MV. Zella Tri. Rept. N°1818
also for
MV. Cellina
" Zella
" Scallo

1:100 SCHEMA IMPIANTO
FORZA COPERTA

M/N CELLINA
NLT/17
Foundation
1236-0146

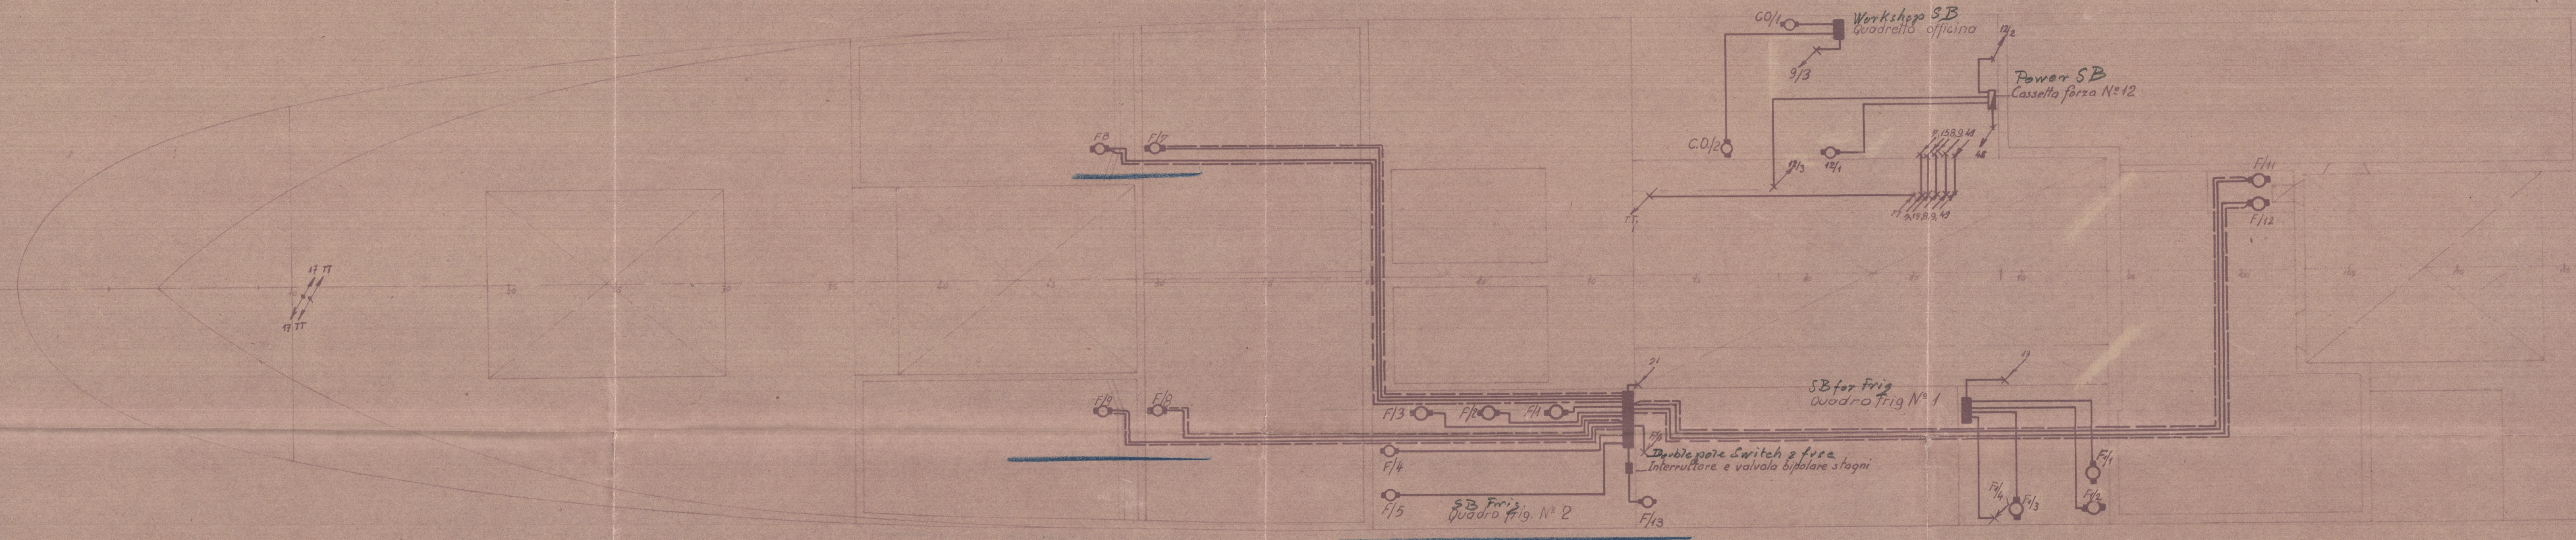
Subdivision of Circuits
to be in accordance with
Section 7 Clause 1.

Control of Circuits
to be in accordance with
Section 7 Clause 2 (a).

Sectional Areas of Cables
to be in accordance with
Section 4 and Tables 1 & 3.

Servizi aggiunti
New Circuits
